STATE OF OHIO
DEPARTMENT OF TRANSPORTATION

POR-224/VAR-18.67/VAR

DEERFIELD & PALMYRA
PORTAGE COUNTY

RESURFACING OF US 224 FROM SLM 18.67 - 21.22, SR 14 FROM SLM 25.41 - 28.77, AND SR 225 FROM SLM 5.24 - 11.04 IN PORTAGE COUNTY. ADDITIONALLY, INCLUDES ODNR PARKING AREA WORK NEAR SLM 26.59. INCLUDES BRIDGE WORK TO FOUR STRUCTURES.

P.9

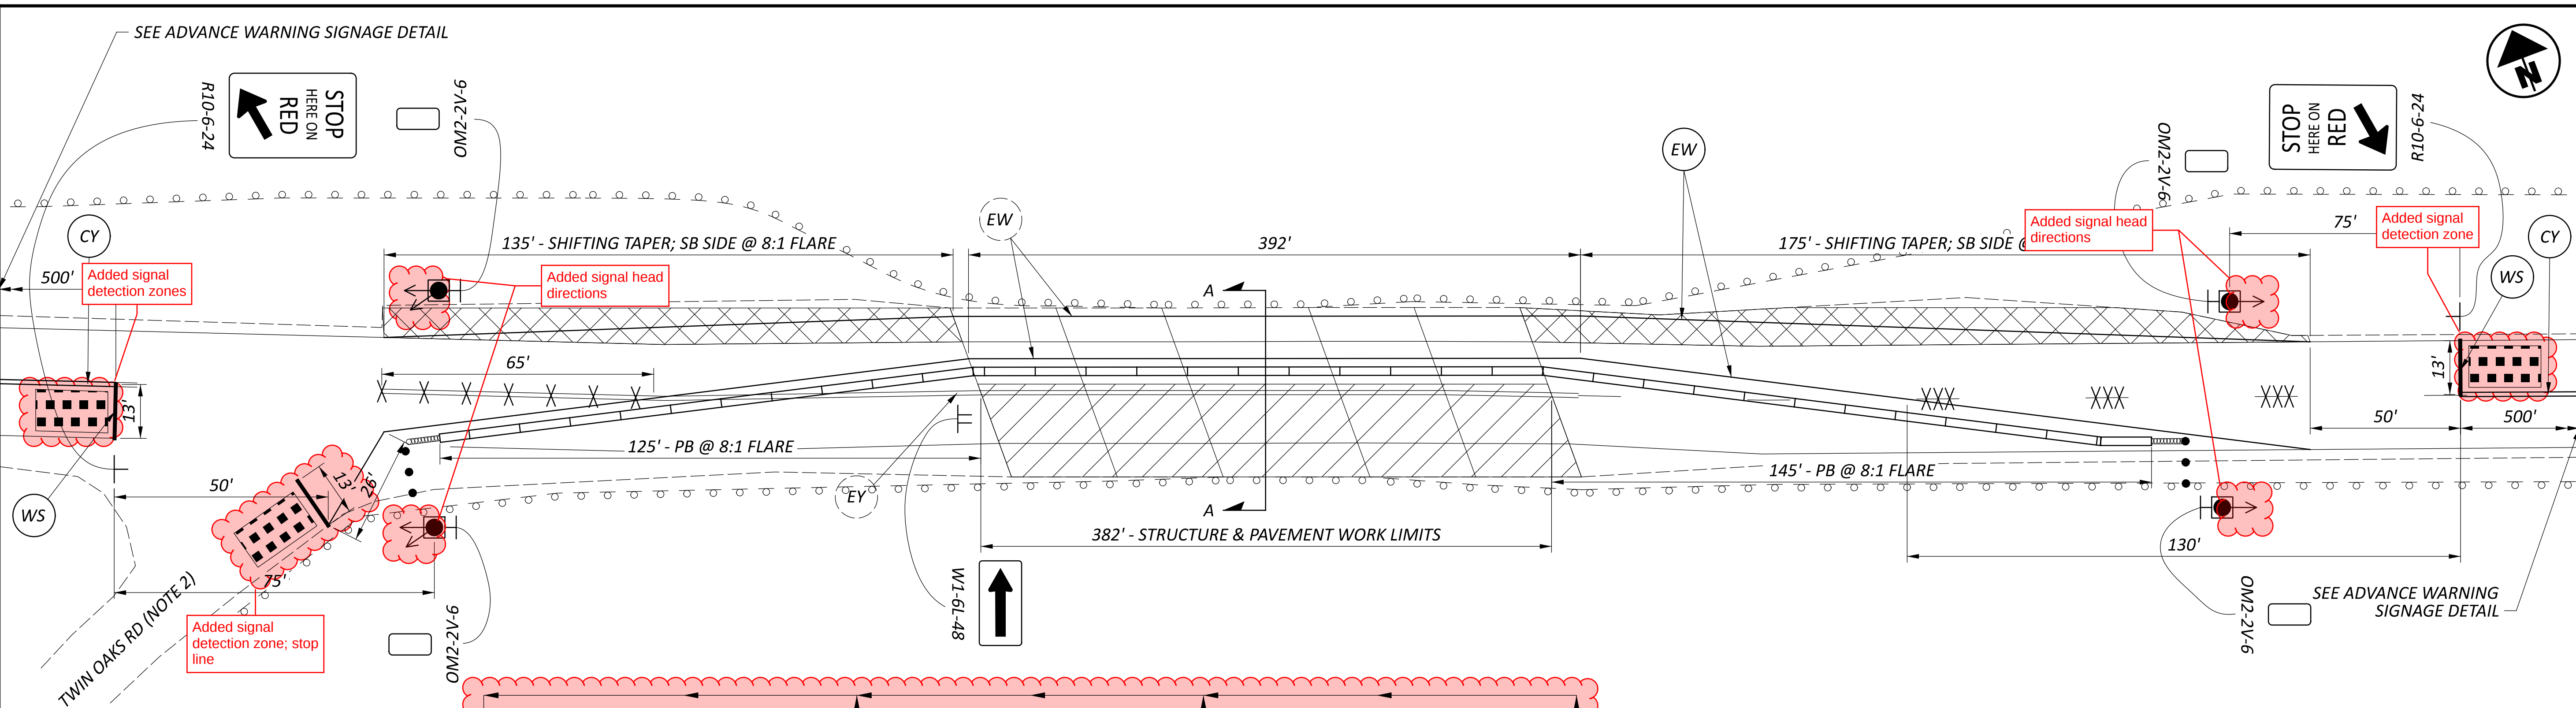
Added signals and detectors to note

BARRIER, ATTENUATOR, OBJECT MARKERS, AND STRIPING ARE QUANTIFIED ON SHEET P-11 R-12. ALL OTHER WORK, MATERIALS, SIGNAGE, SIGNALS, DETECTORS AND EQUIPMENT WILL BE INCIDENTAL TO ITEM 614- MAINTAINING TRAFFIC.

DRAINAGE DETAILS

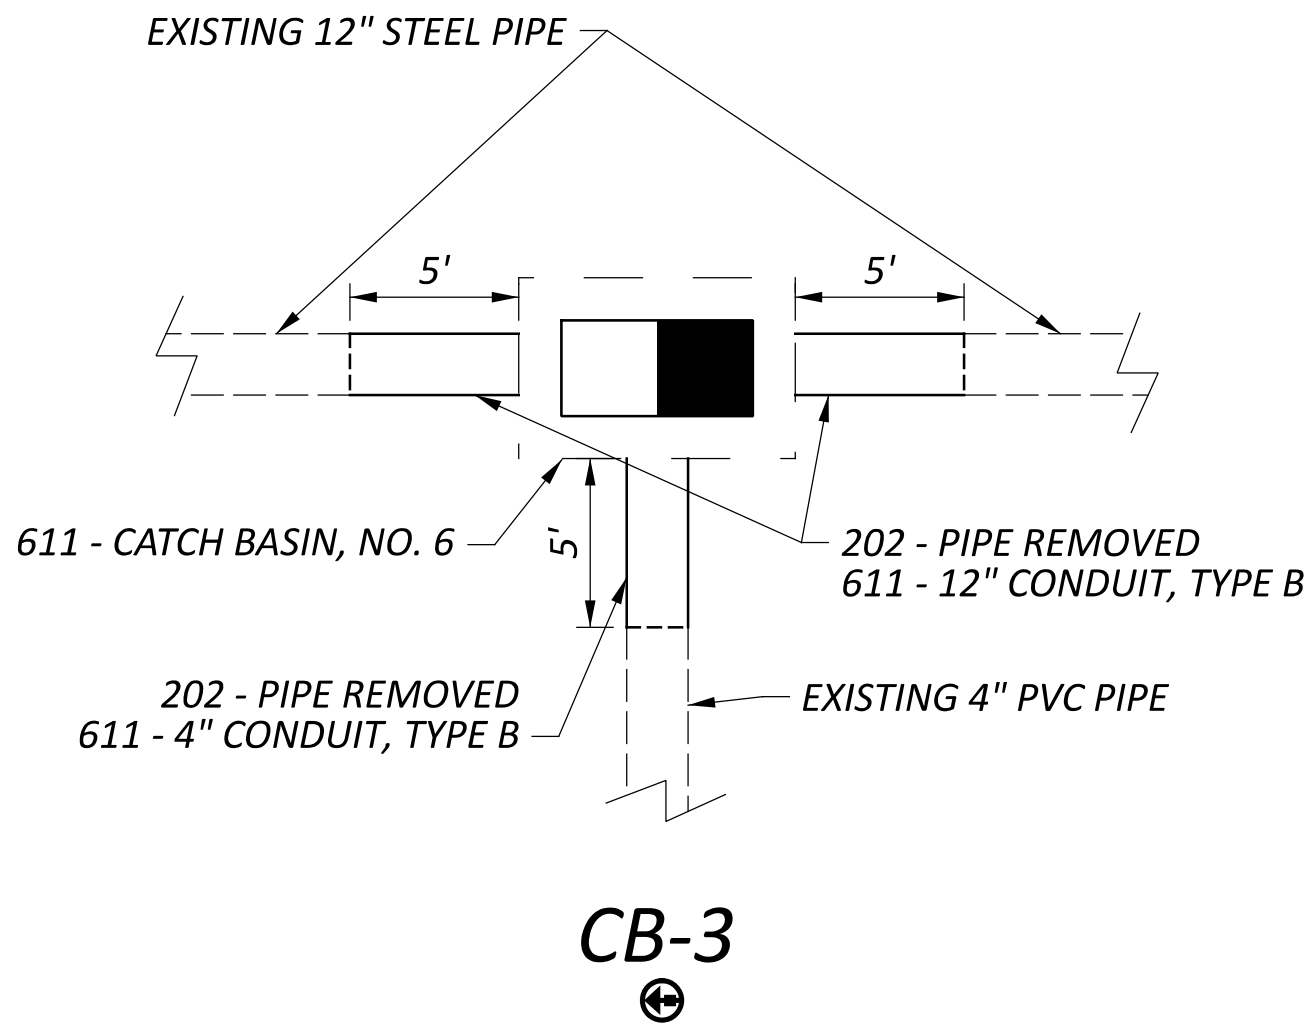
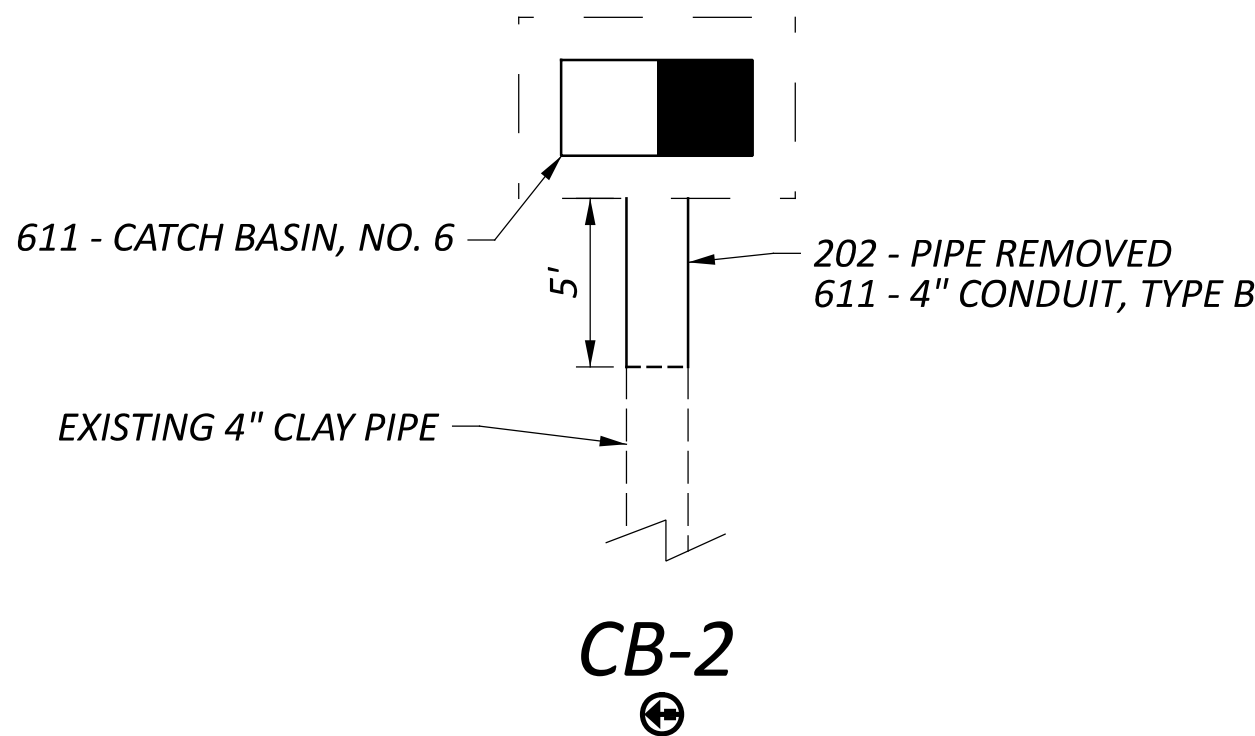
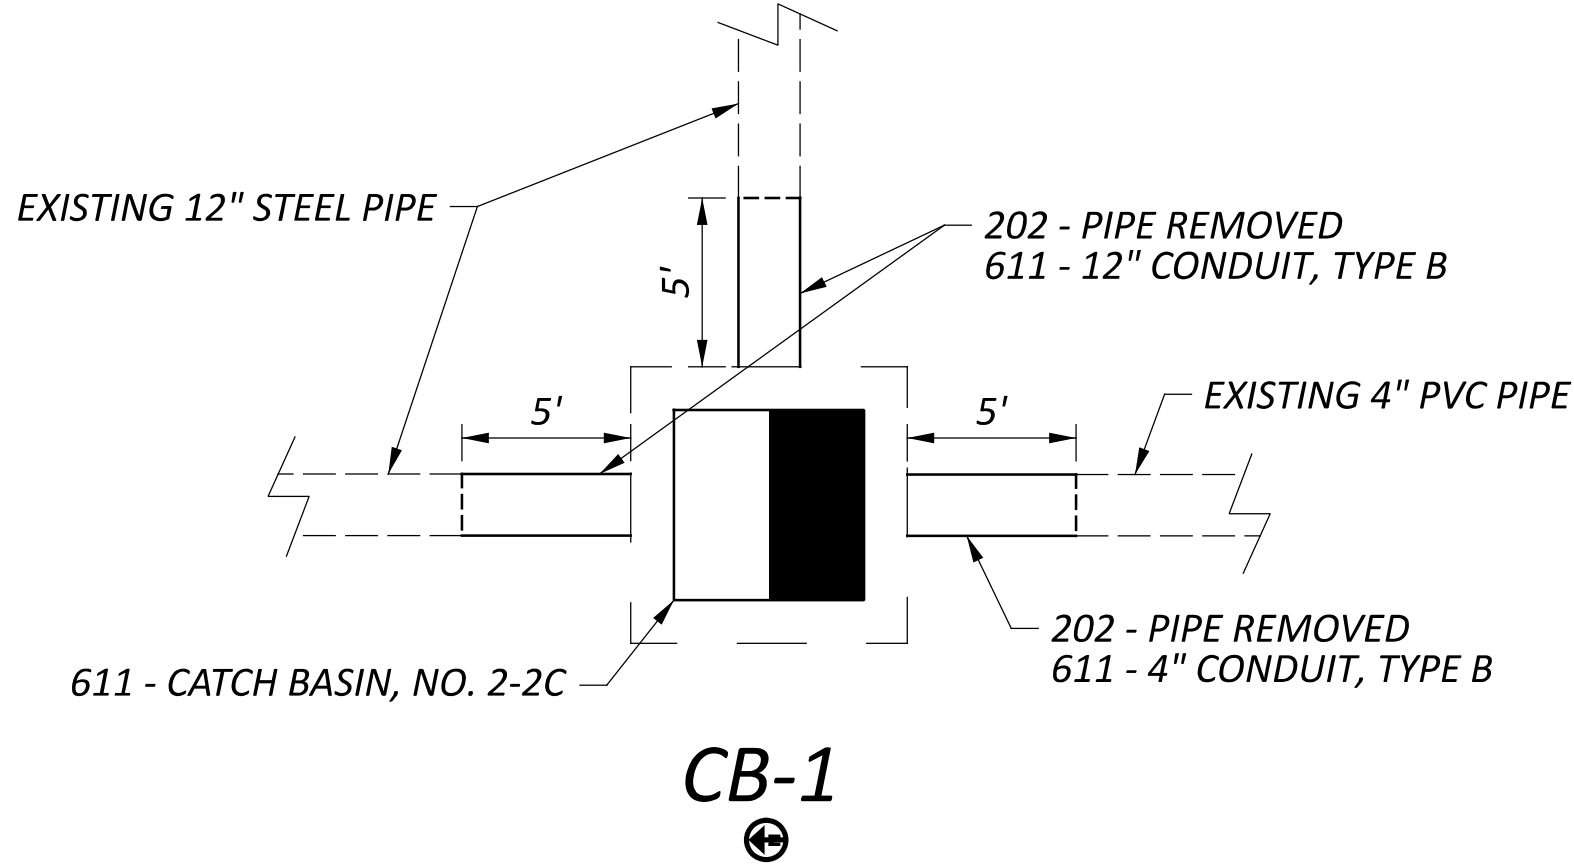
Additional work added

CB-4 - DETAILS
BASIN GRATE ELEVATION: TO BE FLUSH WITH
EXISTING PAVEMENT GRADE
BASIN DEPTH: 3'-6"
PIPE CONNECTIONS -
- SOUTHEAST, TOWARDS TWIN OAKS DR, 12" STEEL:
INVERT ELEV.: 3'-6" BELOW GRATE

PROPOSED WORK LAYOUT

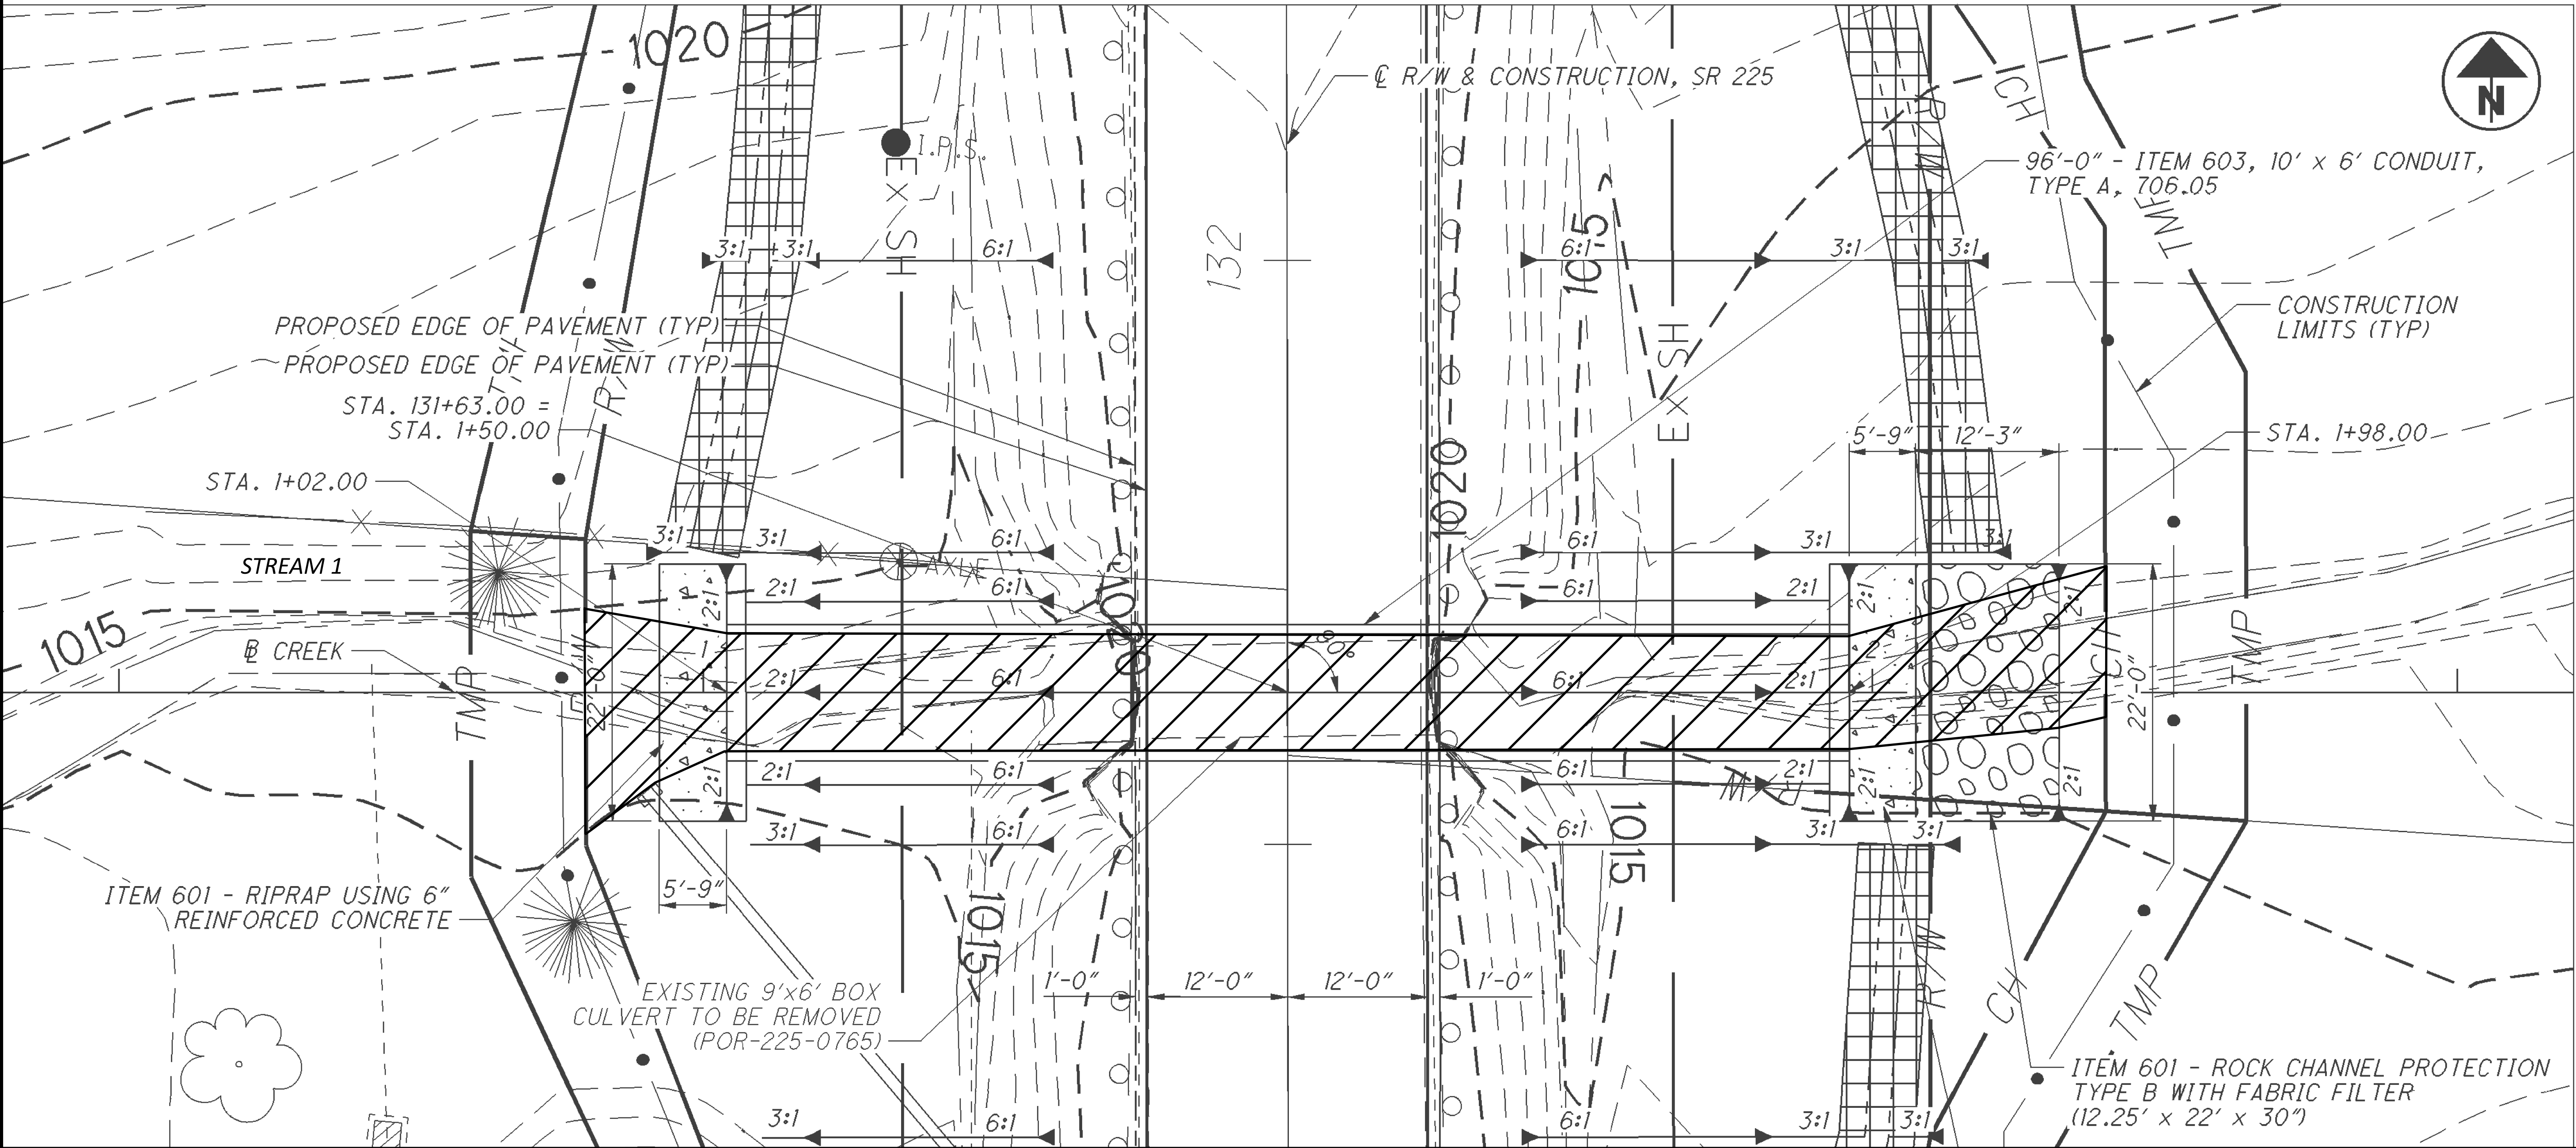
Estimated Quantities table has been revised to properly show work assigned.
No quantity changes.
